**City Planning Commission  
Planning Meeting – January 27, 2015**

**CONSIDERATION – SUBDIVISION DOCKET – 166/14  
Applicant: Solution Automotive & Used Cars Sales, Inc.**

**Prepared By:** Brooke Perry  
**Date:** January 15, 2015  
**Deadline:** February 27, 2015

**Proposal:** Subdivision of Lots 1 and 2 into Lots 1A and 2A.

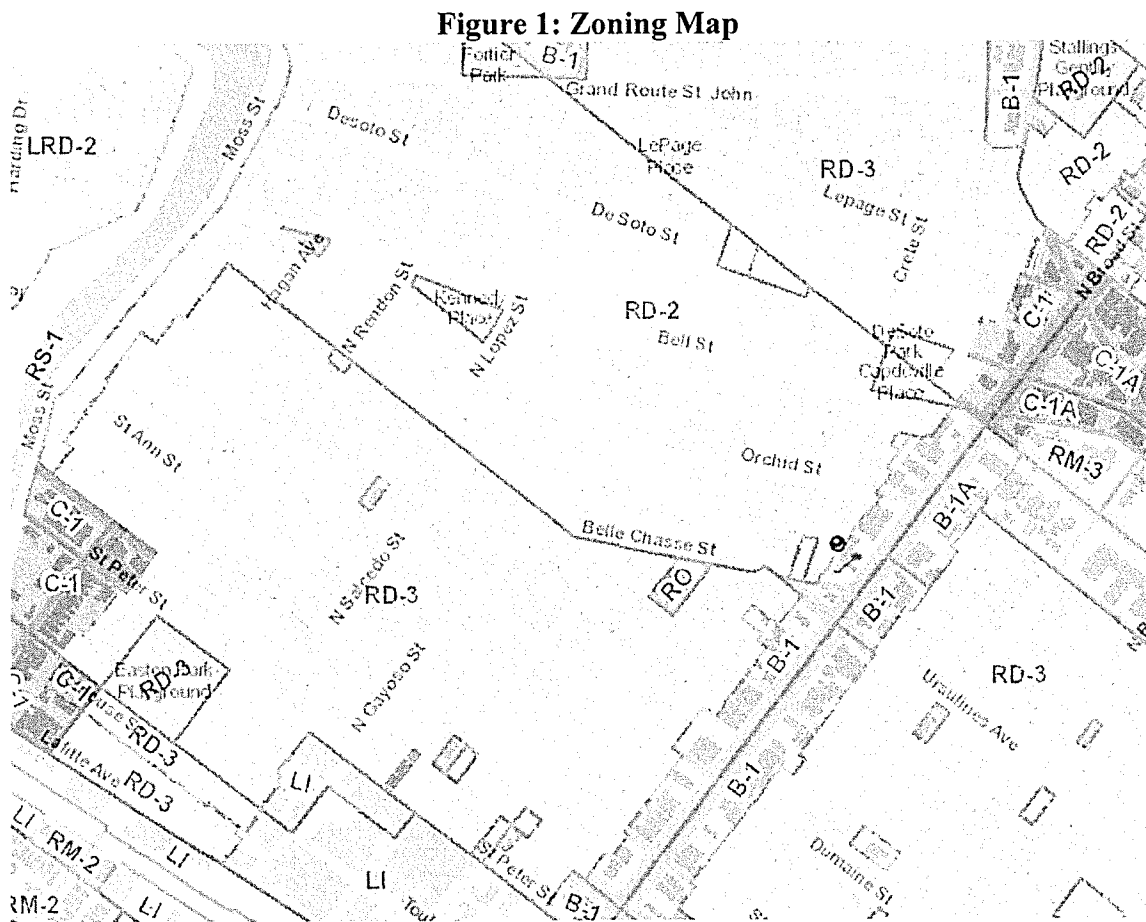
<sup>1</sup> According to the Comprehensive Zoning Ordinance, lot depth is calculated as the average horizontal distance between the front and rear lot lines. Lot 1 has a depth of one hundred feet (100') on the Orchid Street side and a depth of one hundred eleven feet, four inches (111' - 4") on the Belle Chasse Street side; the average of these two distances is one hundred five feet, eight inches (105' - 8").

<sup>2</sup> Proposed Lot 1A has a depth of fifty feet, eleven inches (50' - 11") on the North Broad Street side and a depth of seventy-six feet, six inches (76' - 6") on the Crete Street side; the average of these two distances is sixty-three feet, five inches (63' - 5").

<sup>3</sup> Proposed Lot 1A has a depth of seventy-six feet, six inches (76' - 6") on the North Broad Street side and a depth of ninety-nine feet, ten inches (99' - 10") on the Crete Street side; the average of these two distances is eighty-seven feet, eleven inches (87' - 11").

**Figure 2: Existing and Proposed Required Yards**

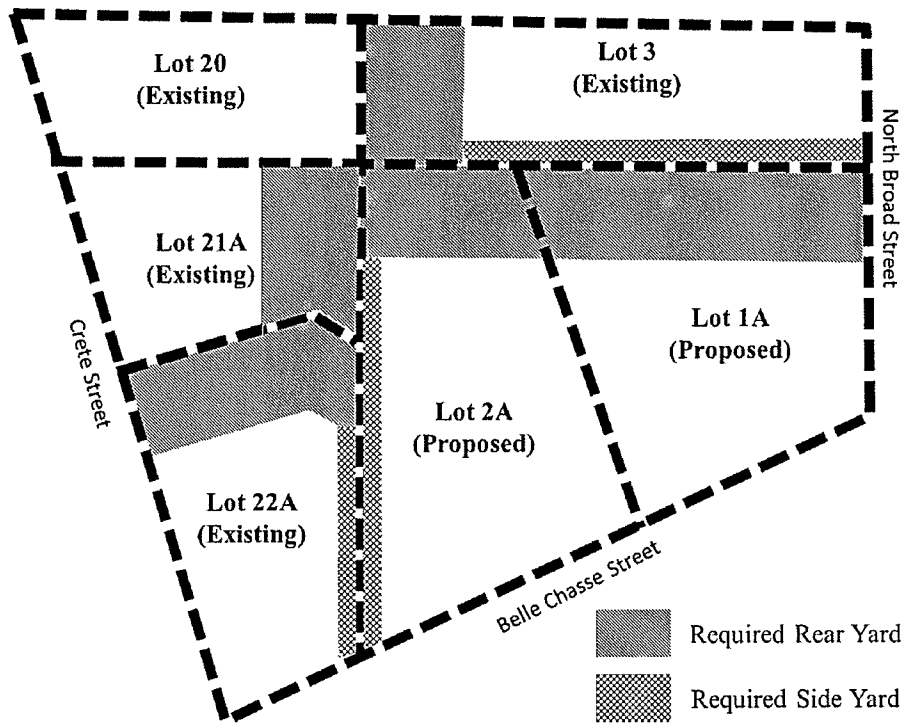
The lot that abuts the proposed lots along the Orchid Street side (Lot 3) is zoned B-1 Neighborhood Business District, however it is currently developed with a single-family residence. Thus, the regulations of the RM-1 Multiple-Family Residential District apply, which require a minimum side yard width of three feet (3') and a minimum depth of rear yard of twenty feet (20'). The proposed subdivision would result in the required rear yard of proposed Lots 1A and 2A abutting the required side yard of existing Lot 3, which conflicts with standard a of **Article 5, Section 5.1.8 – Reversal of Lot Frontage**. The proposed subdivision would also result in the required rear yard of proposed Lot 2A abutting the required rear yard of existing Lot 3, which does not conflict with the standard.

The lot that abuts the proposed Lot 2A along the Crete Street side (Lot 22A), is zoned RD-2 Two-Family Residential District and is developed with a single-family residence. The RD-2 District requires a minimum side yard width of three feet (3') and a minimum depth of rear yard of twenty feet (20'). The proposed subdivision would result in the required side yard of proposed Lot 2A abutting the required rear yard of existing Lot 22A, which conflicts with standard b of **Section 5.1.8**.

The lot that abuts the rear of proposed Lot 2A along the Crete Street side (Lot 21A), is zoned RD-2 Two-Family Residential District, and is developed with a single-family residence. The proposed subdivision would result in the required side yard of proposed Lot 2A abutting the required rear yard of existing Lot 21A, which also conflicts with standard b of **Section 5.1.8**.

The lot that is opposite the proposed lots across Belle Chasse Street (Square 351, Lot "Triangle") is zoned B-1 Neighborhood Commercial District and is currently developed with a beauty salon. The B-1 District does not require side yards unless the property is abutting a residential district. Lot Triangle does not abut a residential district; therefore it has no required side yards. Thus the proposed subdivision is not in conflict with standard c of **Section 5.1.8**.

- The applicant shall be granted a waiver of **Section 5.1.8** of the *New Orleans Subdivision Regulations*, which requires the City Planning Commission to look with disfavor upon proposals for the reversal of lot frontage, to permit the creation of a lot that will result in required rear yards abutting required side yards, and a required side yard abutting a required rear yard.

*A Resubdivision of Lots 1 & 2 into Lots 1A & 2A.*

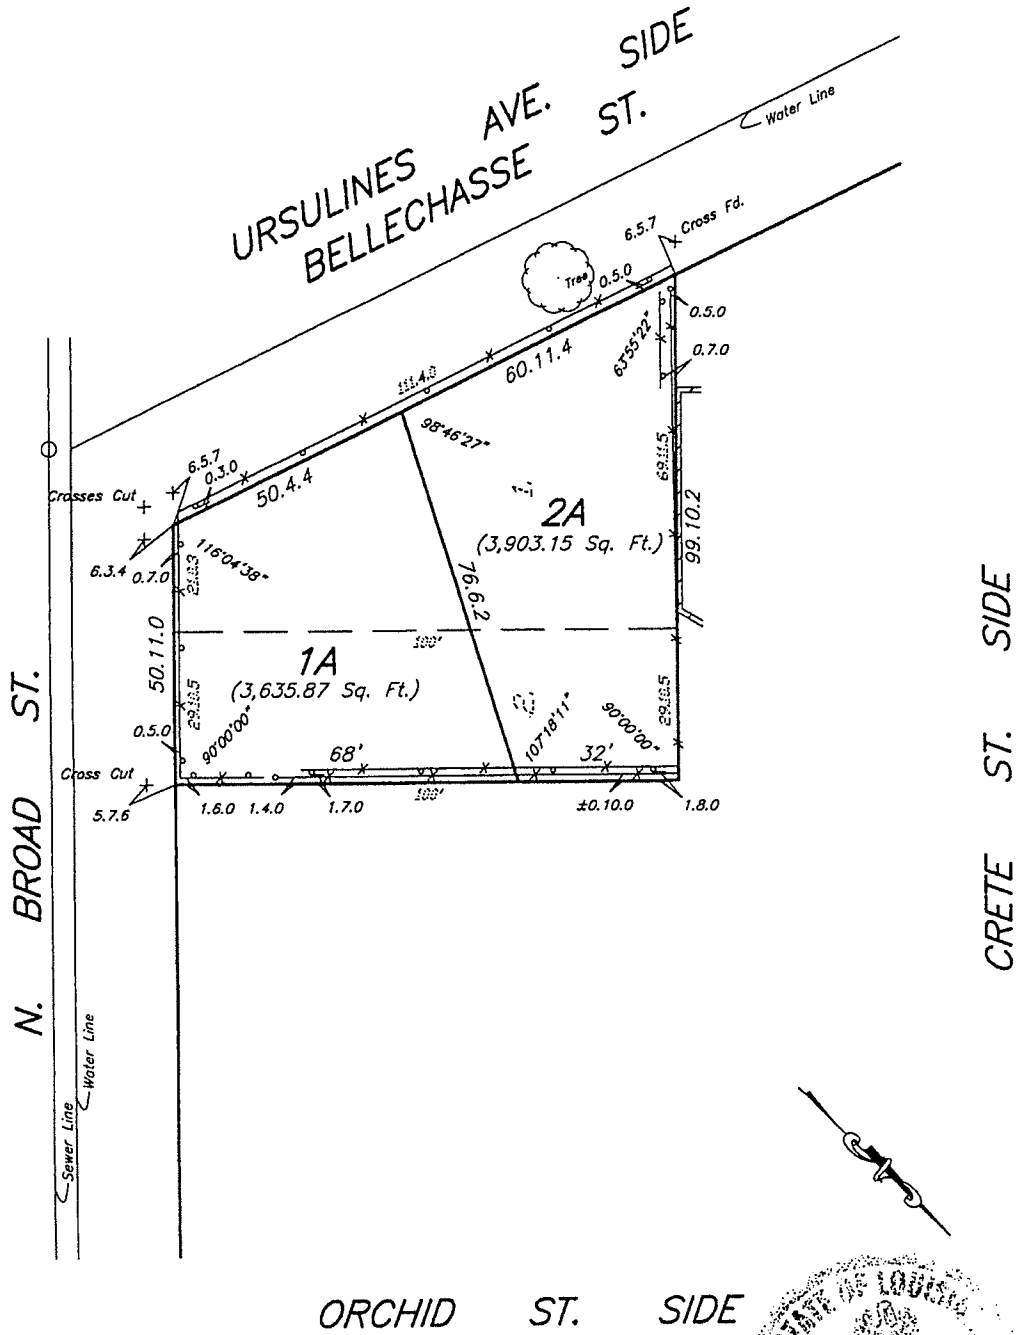
The representative of the Sewerage and Water Board stated that water facilities are available as shown in the proposed subdivision docket plan. Sewer facilities are available for Lot 1A, but not Lot 2A. Sewer can be made available to Lot 2A with the proper extension in accordance with Sewerage and Water Board’s policy with developers for extension of mains. Sewer and water house connections are not shown; therefore, a note should be shown on the plans stating sewer and water house connections are the property owner’s responsibility.

The proposed Lot 1A meets the required minimum lot width of thirty feet (30’), and minimum lot area of three thousand six hundred square feet (3,600 sq. ft.). However, Lot 1A’s depth of approximately sixty-three feet, five inches (63’ - 5”) does not meet the minimum lot depth requirement of ninety feet (90’). The proposed Lot 2A also meets the required minimum lot width and minimum lot area, however its depth of approximately eighty-seven feet, eleven inches (87’ - 11”) does not meet the minimum lot depth requirement. If approved, both proposed Lot 1A and 2A will require a waiver of lot depth from the Board of Zoning Adjustments.

- The applicant shall secure approval from the Board of Zoning Adjustments for any necessary waivers, including lot depth, for proposed Lots 1A and 2A.
